Process Sheet

: ARM

: D3560042

Subject: RE: D3560-044 & -042 Cracking

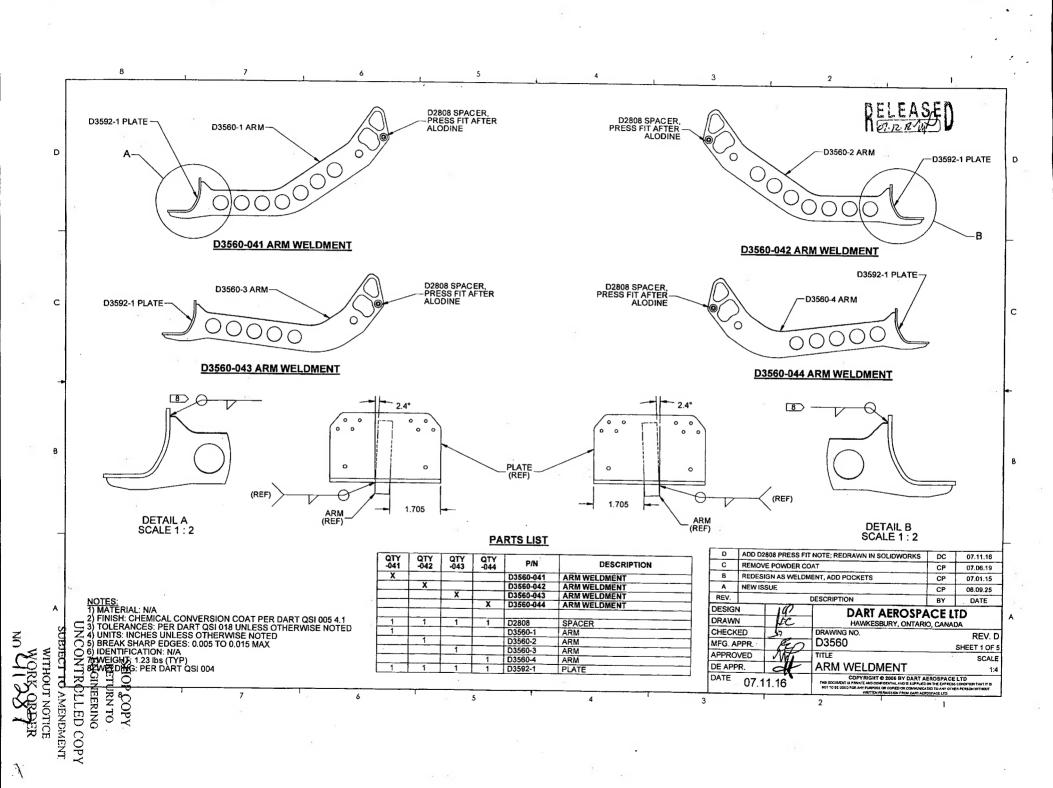
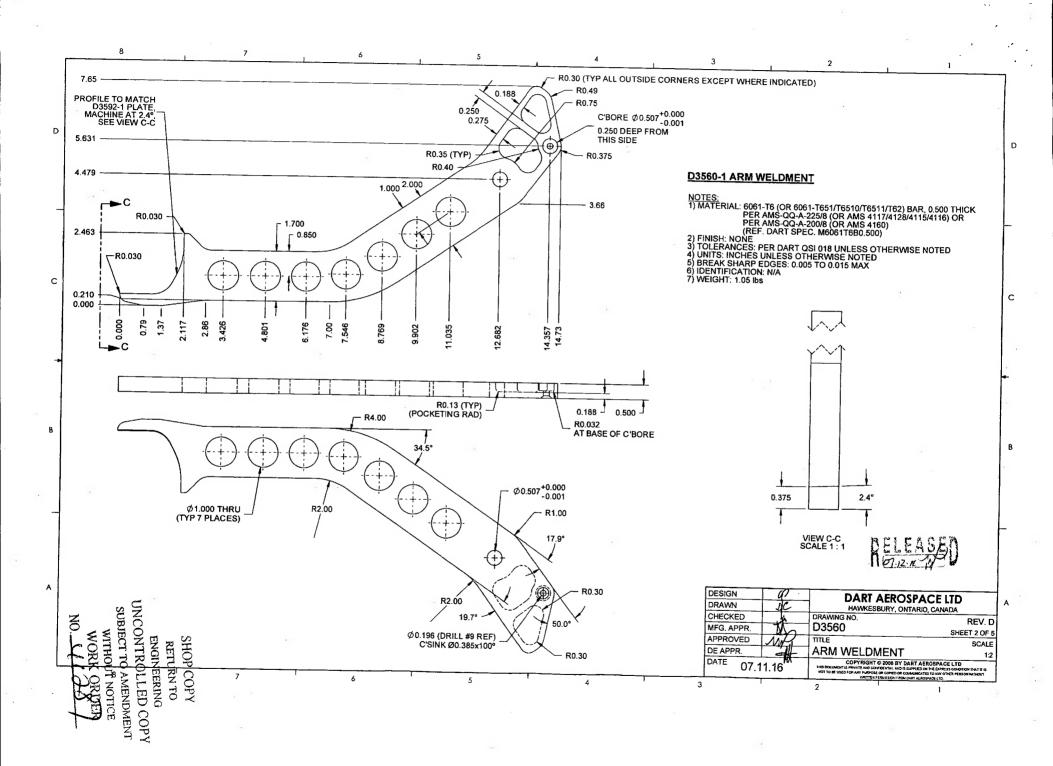
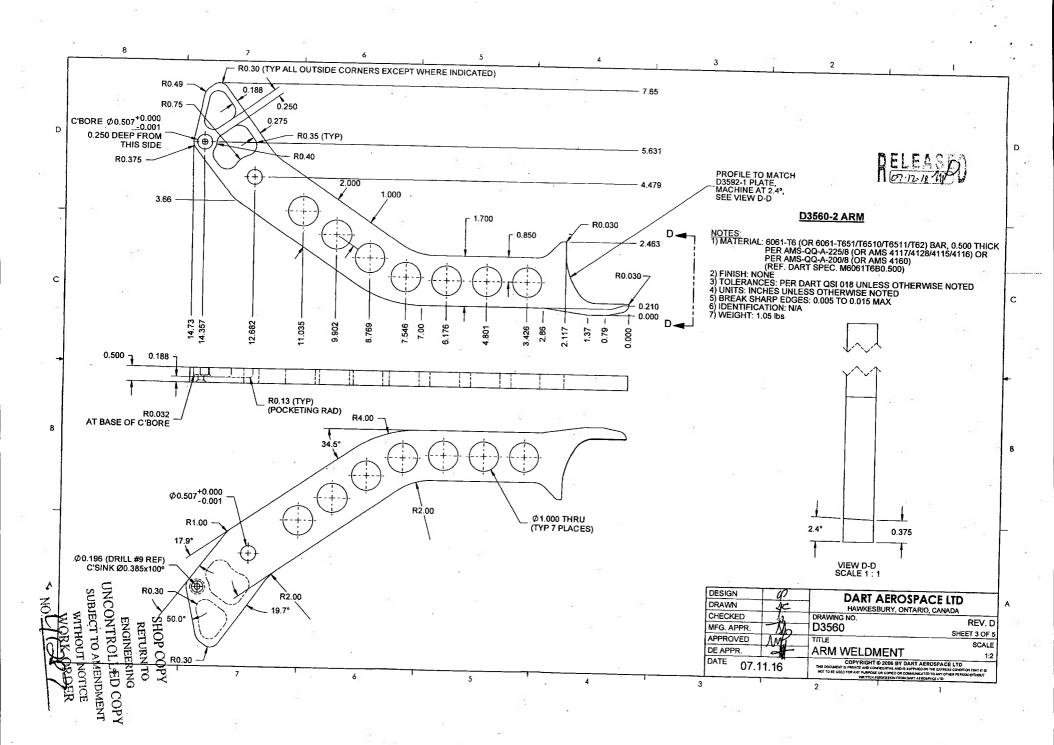
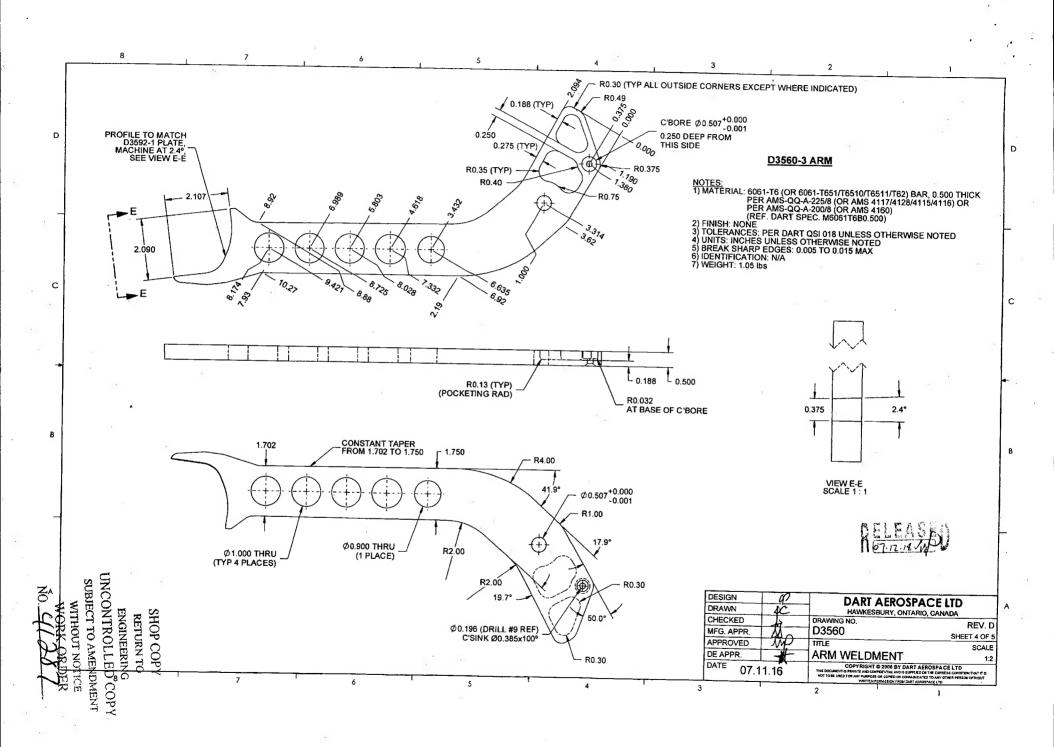
NCR: 4	1287-	S WO	ORK OR	DER NON-CONFORMANCE	(NCR)			
DATE	STEP	Description of NC Section A	Description of NC Section A Corrective Action Section B Initial Action Description Sign & Date			Verification Section C	Approval Chief Eng	Approval QC Inspector
દૃષ્યિક	7.0	Durking welding inspection It was found that @ parts have cracks in the 0 35921 Plates from welding R.C.: Grain runs along the weld.	Off Bloghs	Action Description Chief Eng SCRAP and Destry Of (2) As per email From Dand shephard to Alanstache on 8/9/10 @ 1:36 pm No Repker See CAR 08-026	SAV 58 (09.11	P Selvel	ord off is	ે હાઇસિટ

We have 13x D3560-044 and 1x D3560-042 that have cracks all but 1 in the same location. Attached image D3560-044 Crack 1 shows where 13 of the 14 cracks occurred. D3560-044 Crack 2 shows where the other crack occurred. The cracks shown in D3560-044 Crack 1 vary in depth from roughly 3/32 to ½ inch. I discussed this with Chris and Peter the consensus opinion is the parts are scarp. Further discussion with Chris indicates that changing grain direction to 45 degree on the sheet metal part may lower the scrap rate but not eliminate it. This has been done on a previous deviation with a less scrap. D3560-044 Crack 2 appears to just be an anomaly.

I am not comfortable with any sort of repair to these parts.

I think that all 14 parts should be scrapped.

And, at the risk of stating the obvious, we need to revisit the manufacturing process of this joint.

My preference, as it was a couple of years ago, is to eliminate this weld.

However, the geometry in that area is a little tricky. Suggest we generate an NCR or PAR or whatever.
